Approval of the Tar, Roanoke, and Cape Fear-Neuse Hydrologic River Basin Models

NC Environmental Management Commission

Water Allocation Committee

July 9, 2014

NOTE : Cedar Creek statistical correlation is poor partly due to:

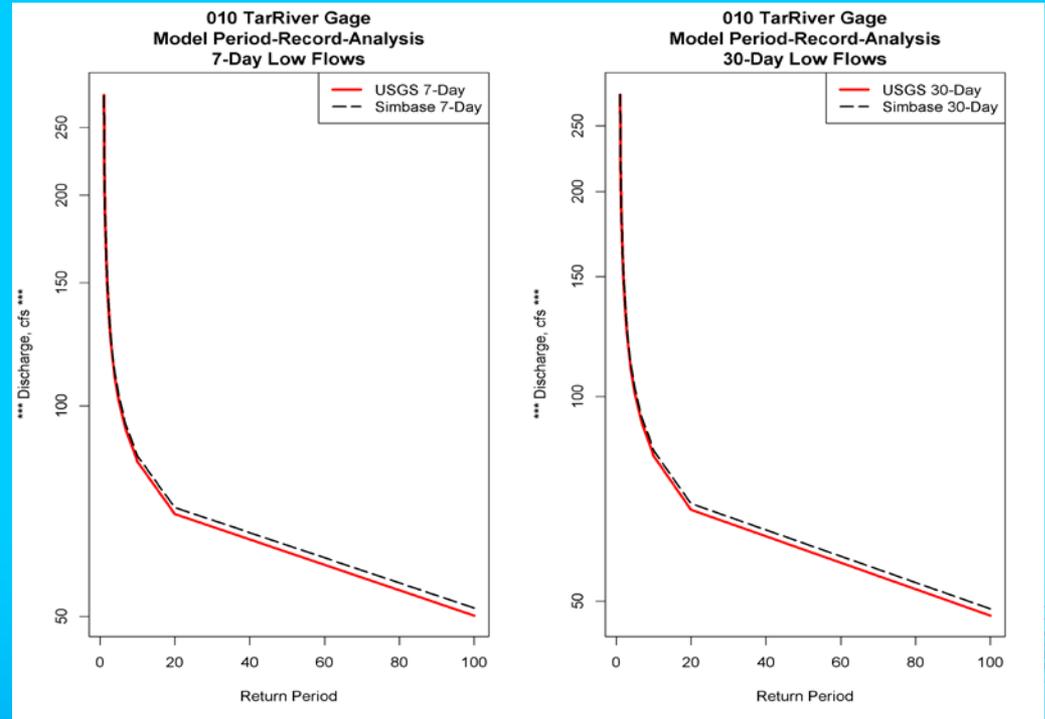
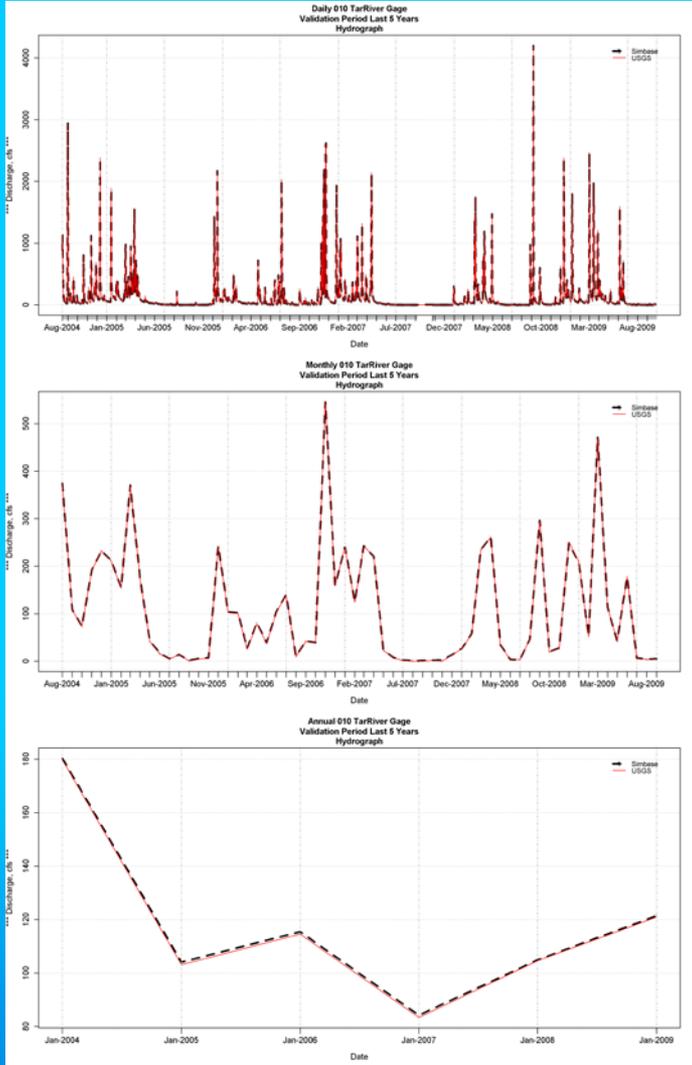
* Cedar Creek gage has only 19 years of flow records; therefore model inflow was generated based on nearby gage flows as synthetic flow data. Other gages have up to 80 years of records.

* Cedar Creek has very small drainage area – only 47.8 sq-miles, and in impaired segment in the headwater part.

* The gage is in a tributary below two very small lakes known as Franklinton reservoirs operated by Franklinton in Franklin County, these two lakes are not modeled as reservoirs with operating rules.

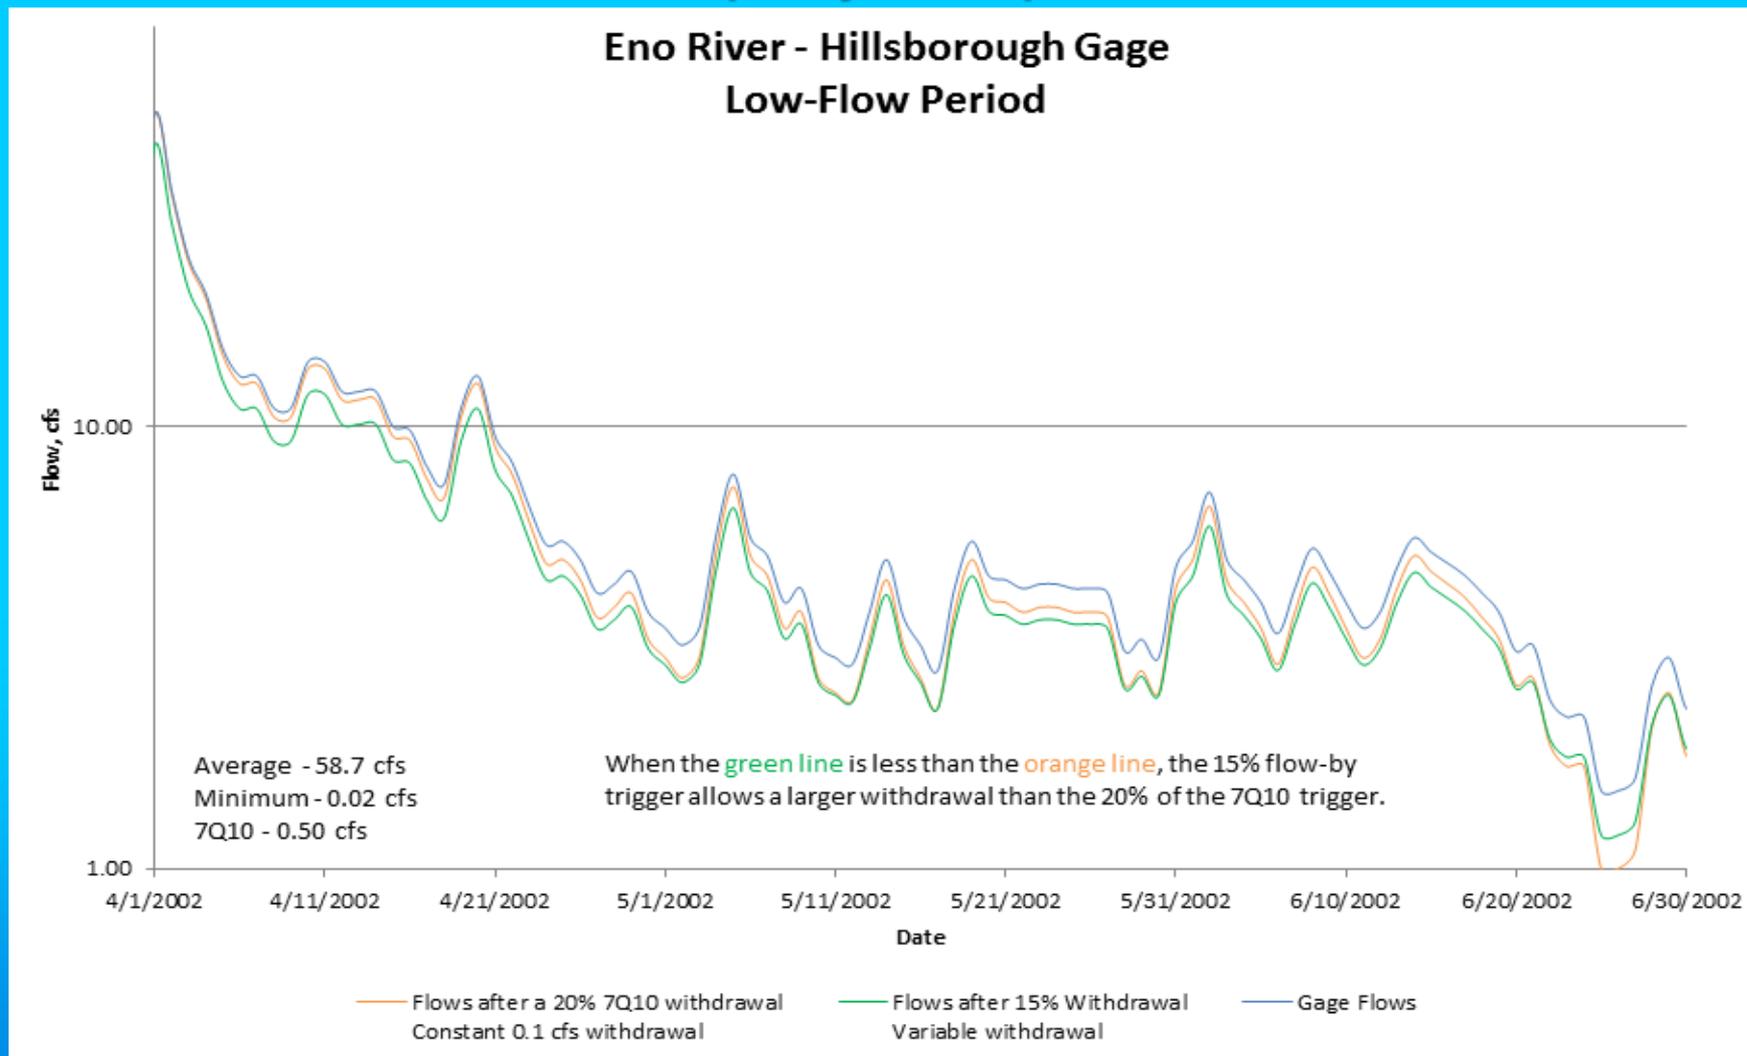
DWR failed to include presumptive set-asides for ecological flows in the model.

Raleigh is correct DWR does not include presumptive set-asides for ecological flows in the model. The statute does not require ecological flows to be included only the ability to predict adverse affected, which we can do. DWR only includes ecological flows that are part of a permit requirement or operational plan of a federal project.
